IDAP REPORT

Property:	6 Highfield Crescent STRATHFIELD Lot: 4 DP: 28880 DA2021/6
Proposal:	Demolition of an existing dwelling house and outbuilding and the construction of a two (2) storey dwelling house with basement level, swimming pool, front fence and associated landscaping works.
Applicant:	H Habib
Owner:	R Hammoud and I Hammoud
Date of lodgement:	8 February 2021
Notification period:	19 February to 5 March 2021
Submissions received:	Nil
Assessment officer:	M Rivera
Estimated cost of works:	\$987,772.00
Zoning:	R2 – Low Density Residential – SLEP 2012
Heritage:	No
Flood affected:	No
Is a Clause 4.6 Variation Proposed:	No
RECOMMENDATION OF OFFICER:	REFUSAL

Figure 20. Gross floor area calculation – ground floor.

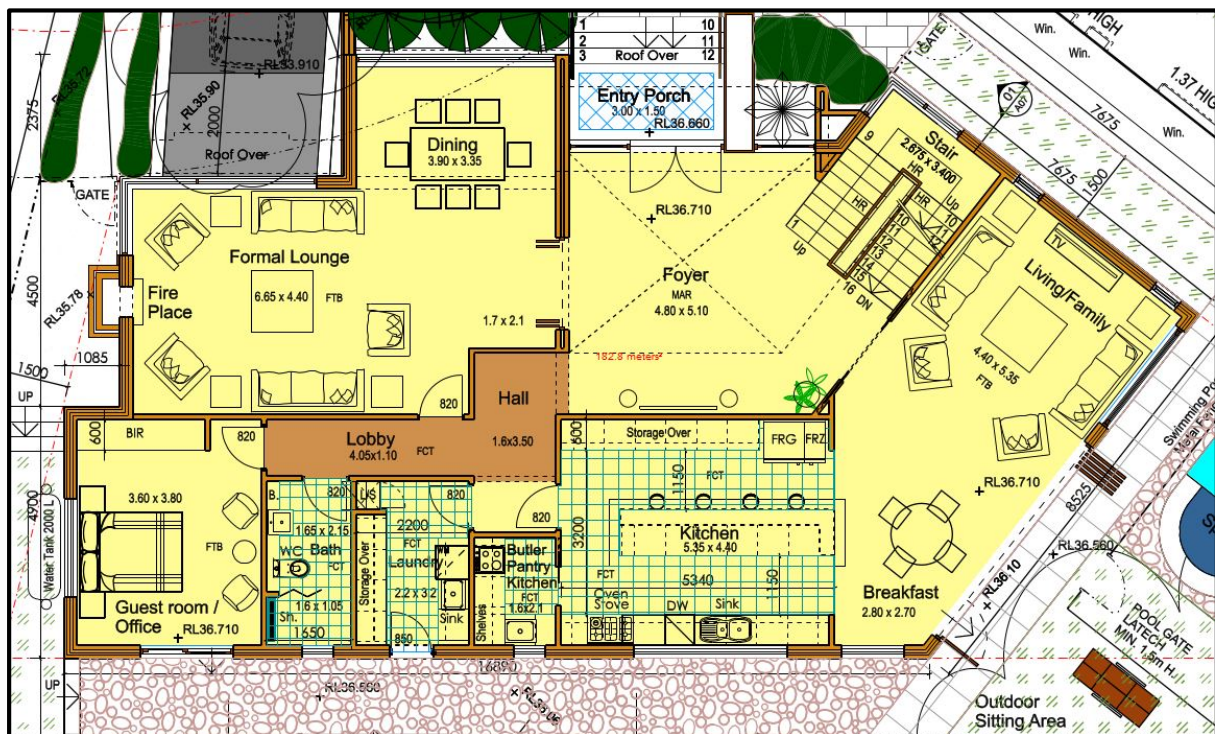
The gross floor area is calculated as follows:

- Ground floor – with no excluded areas = 182.8m²;
- First floor – with the exclusion of a stairwell void and a large void over the foyer (18.9m²) = 158.4m²;
- Basement level – the only areas included in the calculation are the 3rd car space, foyer and excess kerb areas that are not necessary for vehicular access = 34.6m²; and
- Outdoor bathroom = 5.3m².

Total gross floor area is **381.1m²**, which results in a **FSR of 0.66:1**.

The areas calculated by Council are illustrated in areas shaded in yellow in Figures 20 to 23 below.

It is noted that the applicant expressed disagreement in the above calculations. Council has taken a consistent approach when calculating gross floor area and FSR for dwelling houses and ancillary structures and the annotated diagrams above reflect this approach.
